Haweswater Aqueduct Resilience Programme - Proposed Bowland Section

Supplementary Environmental Information Report

Project No: B27070CT
Document Title: Proposed Bowland Section
Supplementary Environmental Information Report
Document Ref.: LCC_RVBC-BO_SEI
Revision: 0
Date: February 2022
Client Name: United Utilities Water Ltd

SCALE 1:25,000	SHEET SIZE A3
DRAWING NUMBER LCC_RVBC-BO-FIG-003-001B	REVISION 1

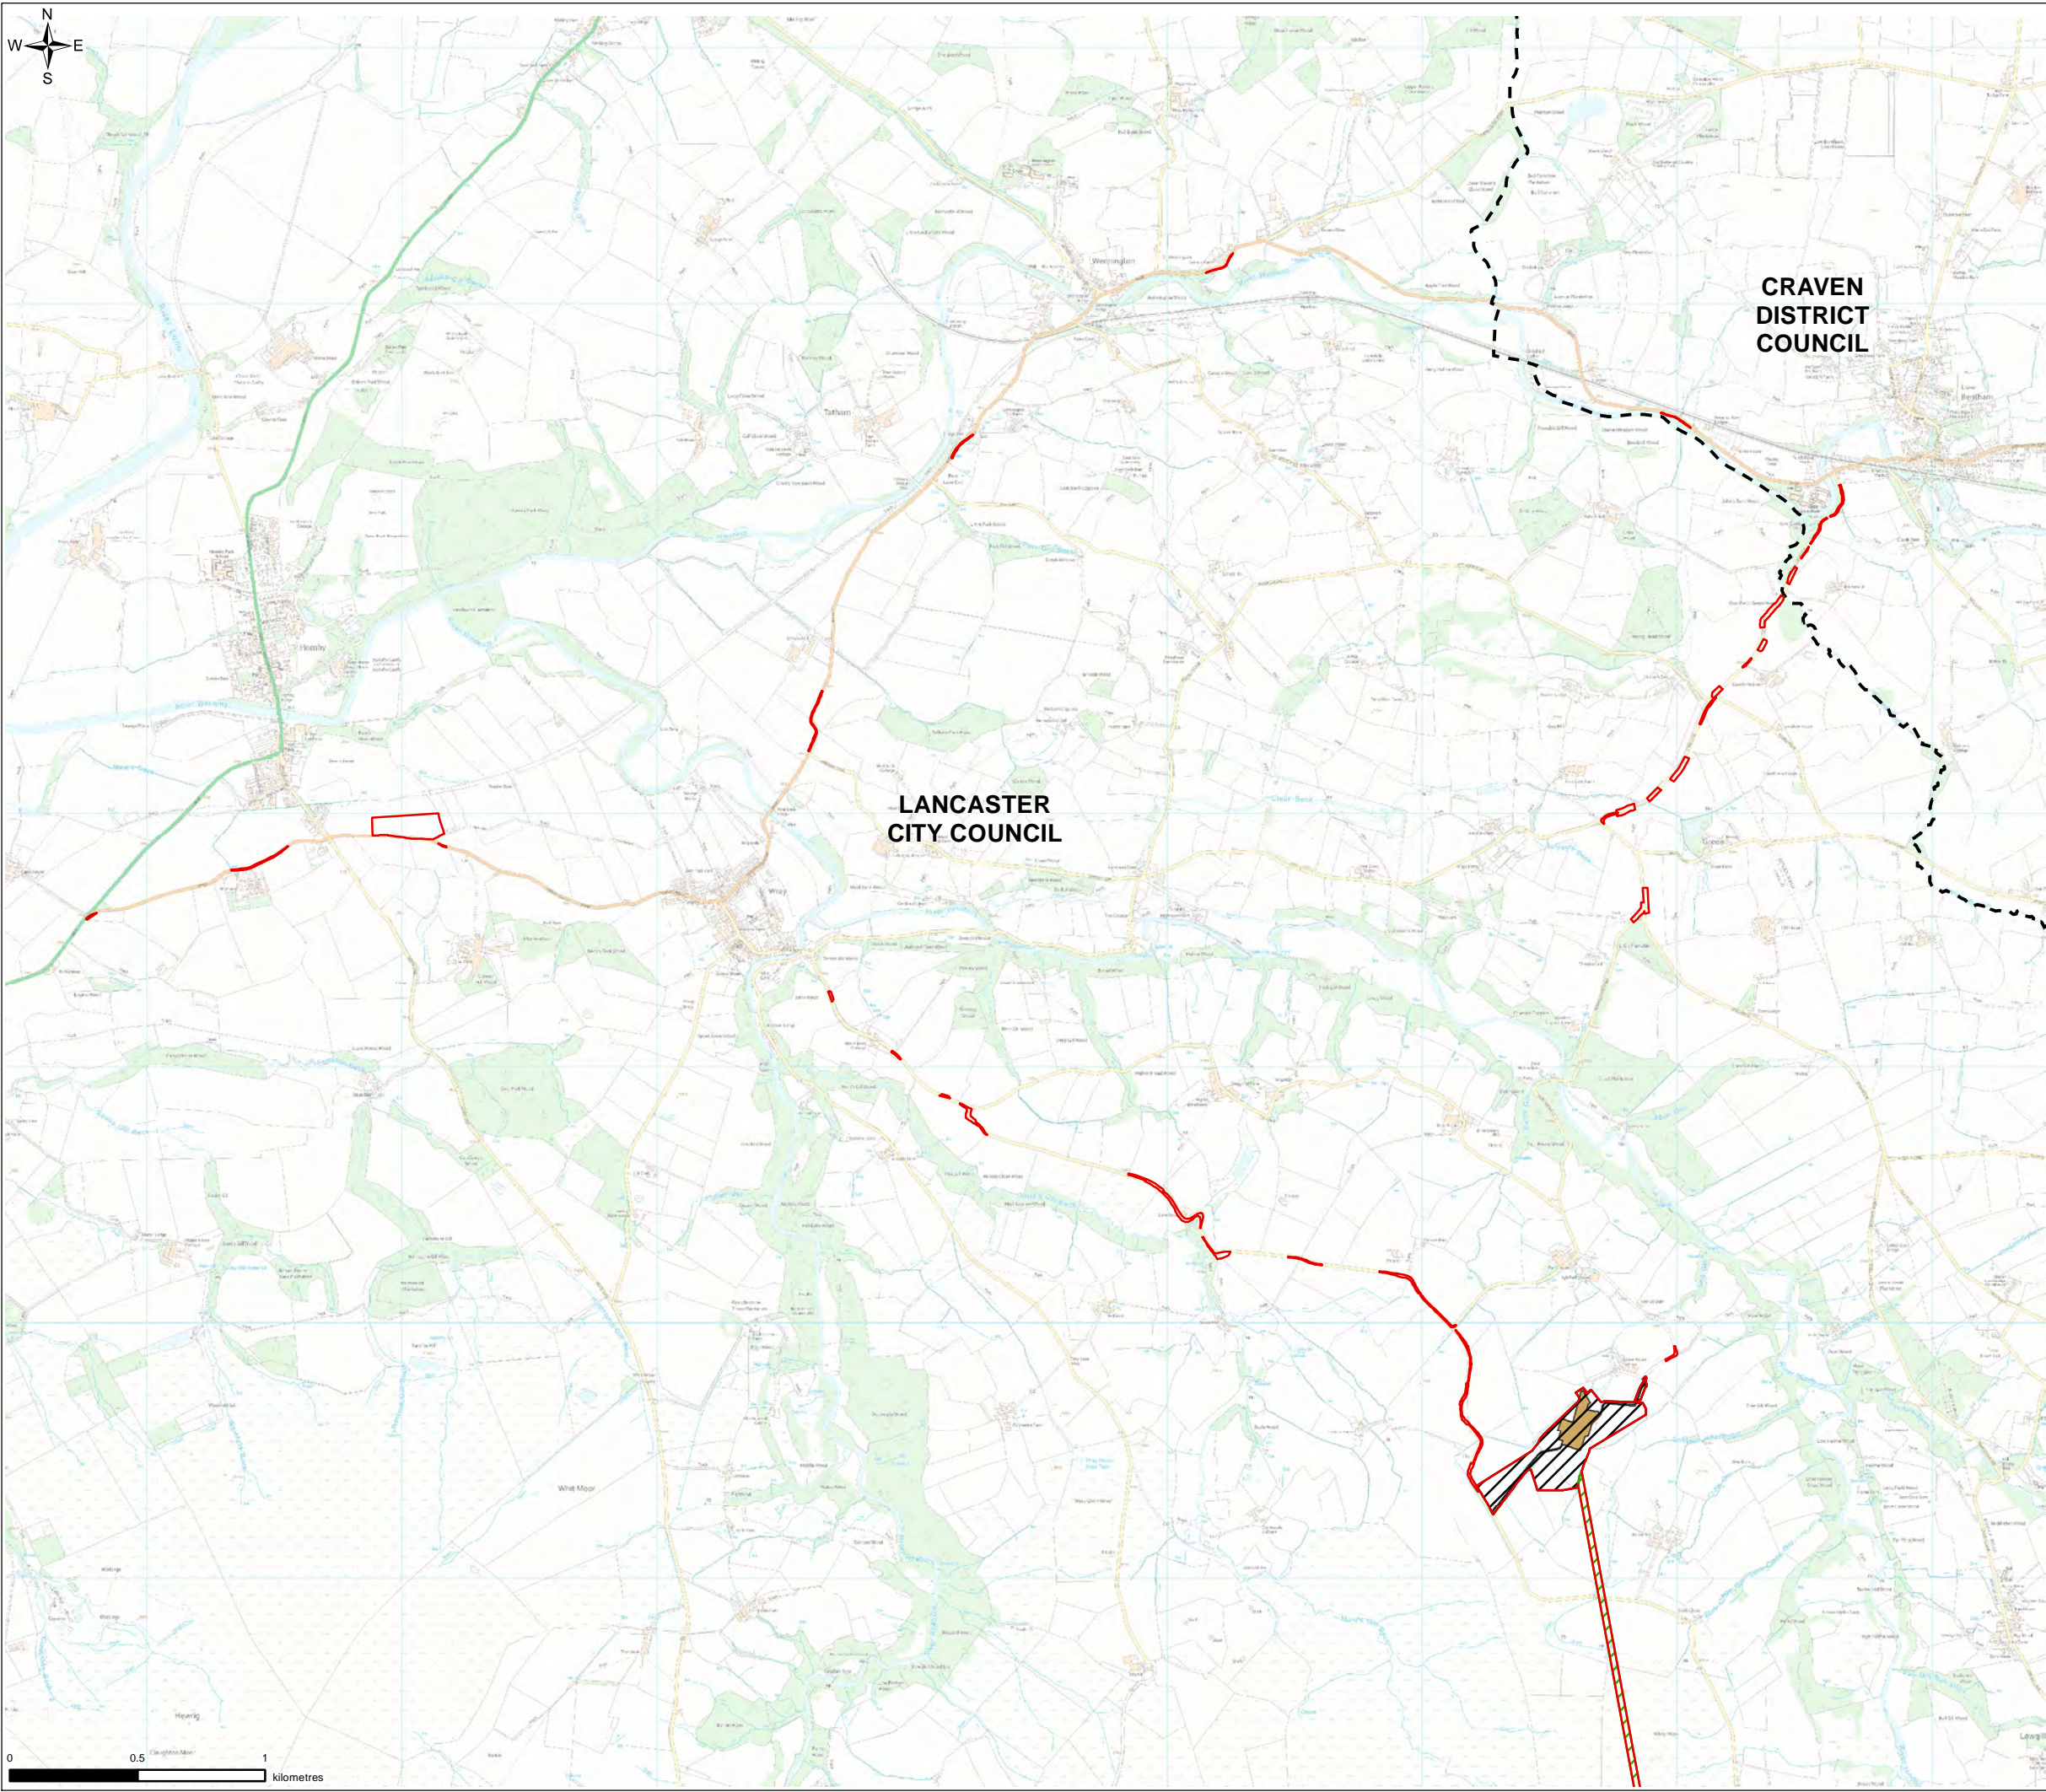
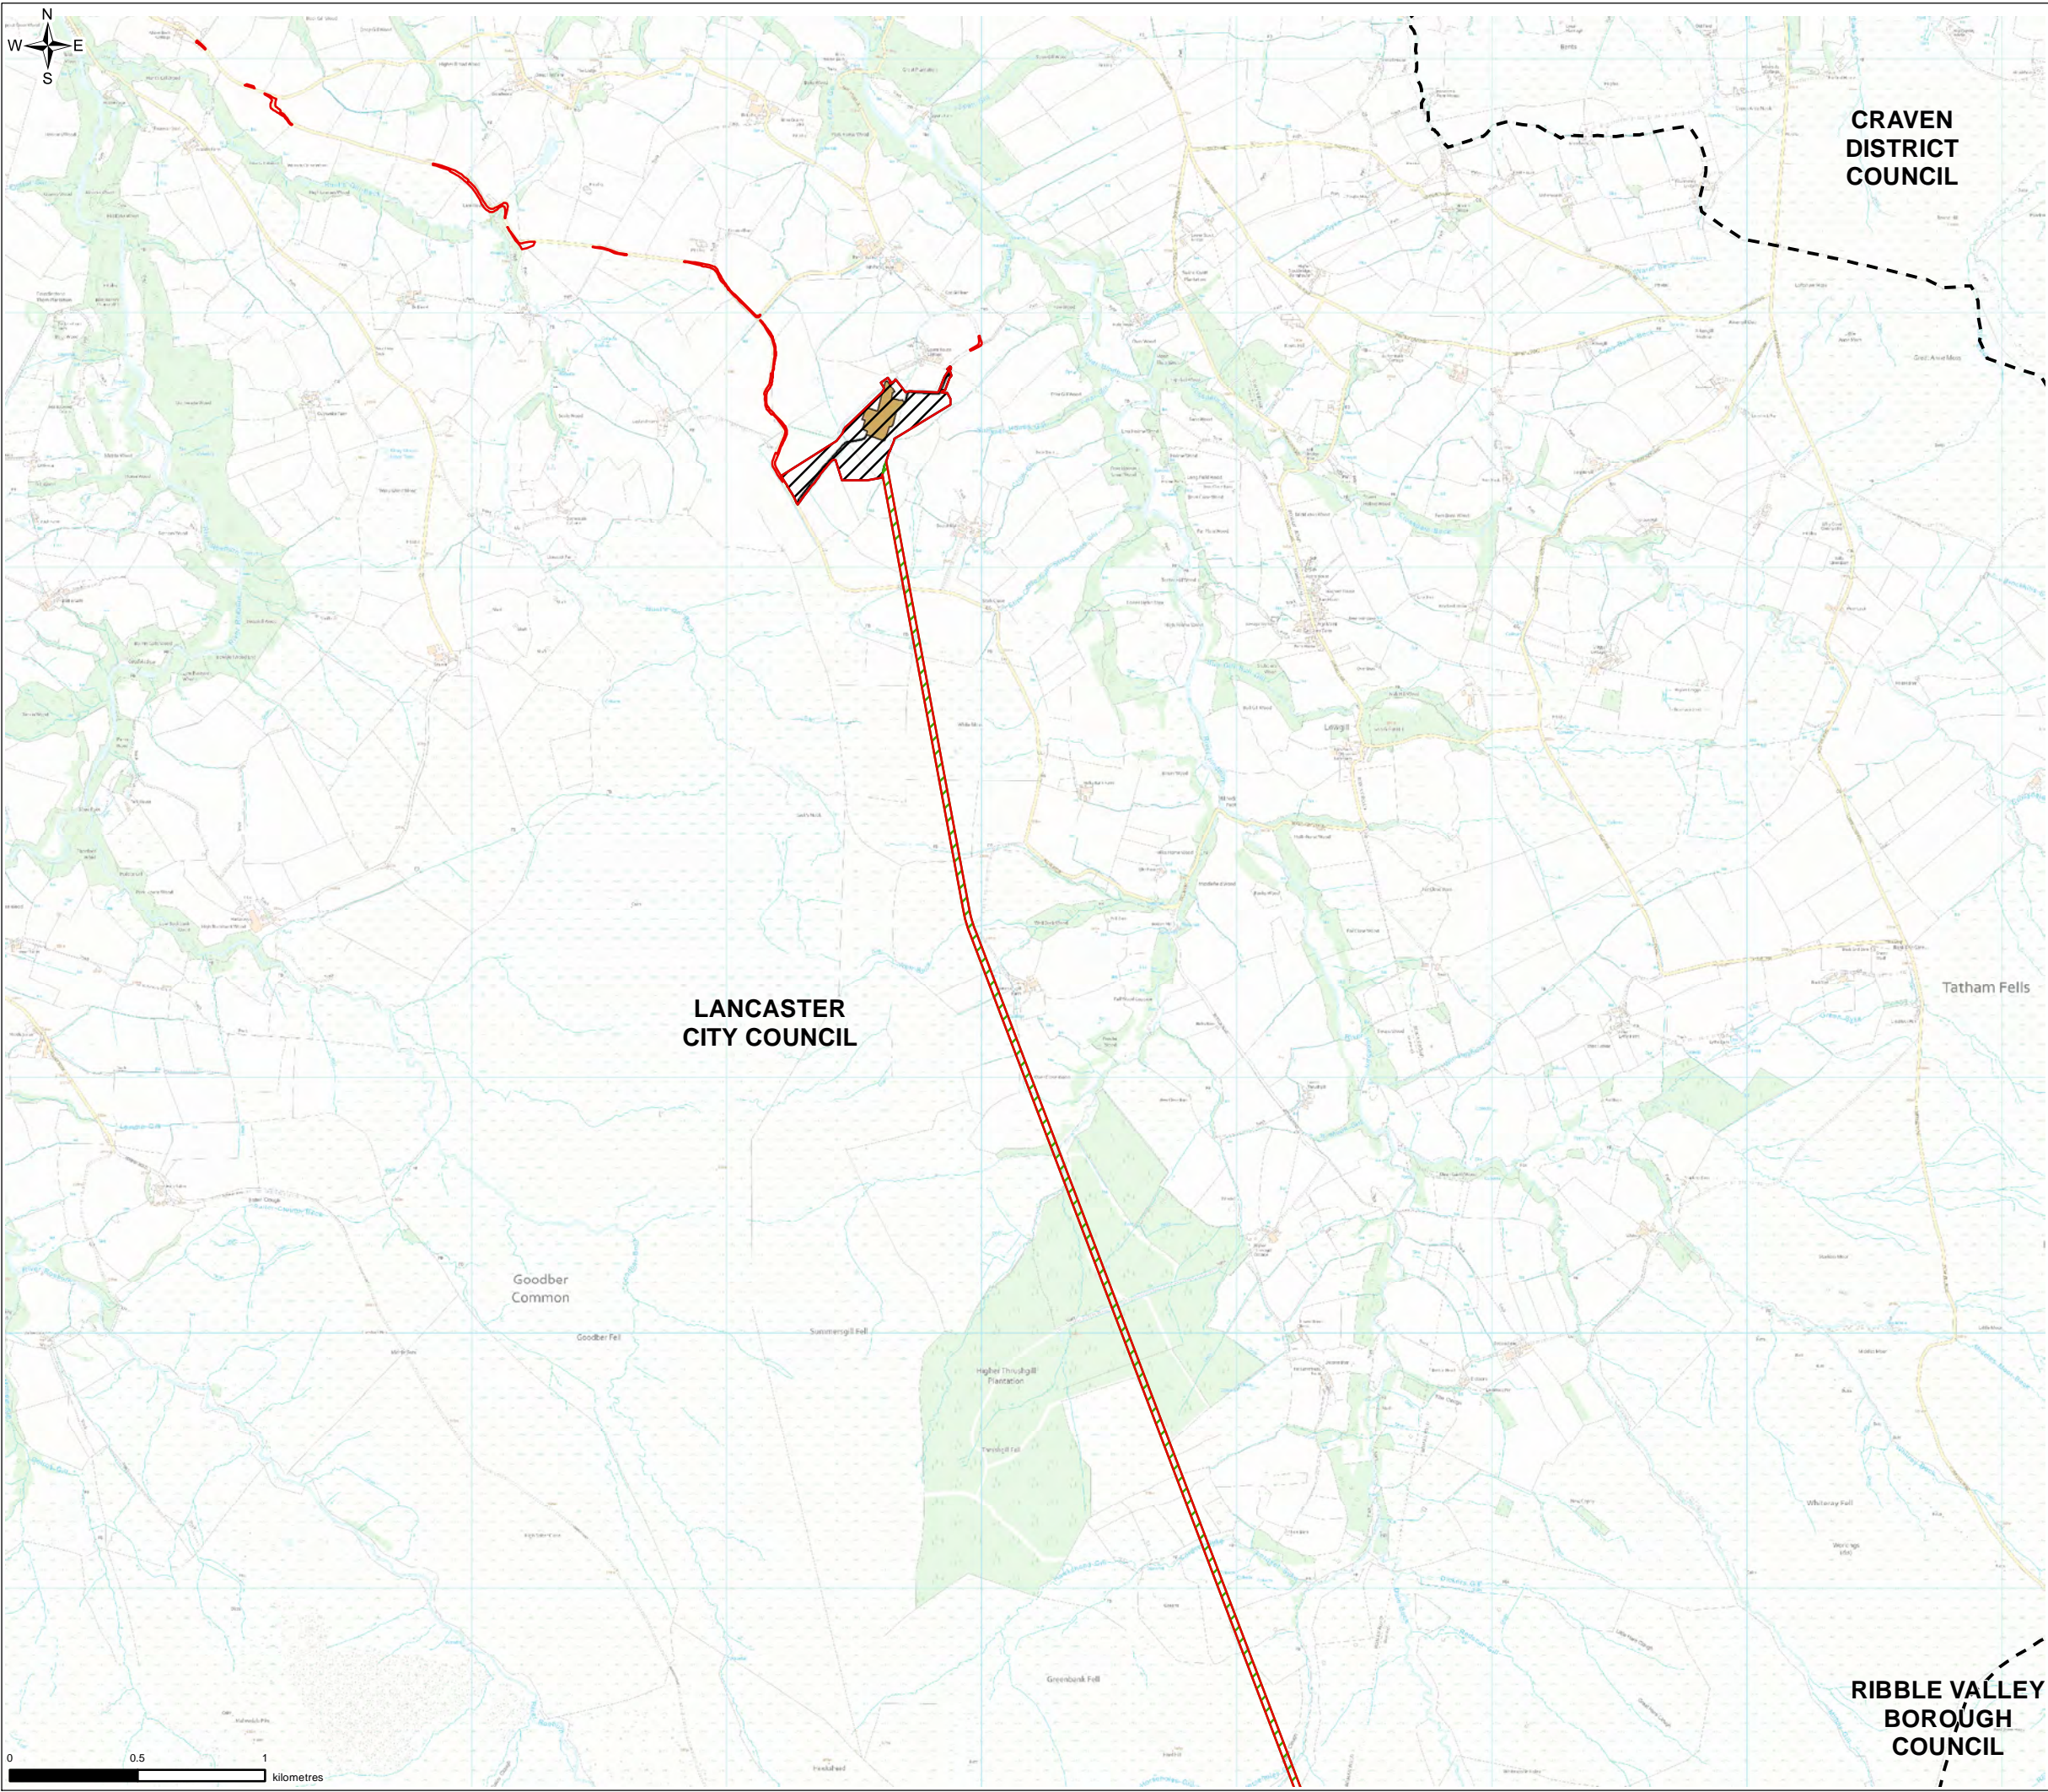
- 28) Figures 3.1a and 3.1b present the updated planning application boundaries for the Proposed Bowland Section; more detailed and larger scale drawings are provided in the February 2022 Revised Planning Application documents. Figure 3.1a focuses on the main construction compounds and the route of the tunnel below ground level. Figure 3.1b shows all the elements of the Proposed Bowland Section at a smaller scale, including satellite compounds and off-site highways works.
- 29) A screening exercise has been undertaken to identify where likely significant effects may arise in relation to the changes and new proposals. This has involved testing the proposed changes against each EIA topic to establish whether any likely significant effect may arise. The outcomes are summarised in Table 6.
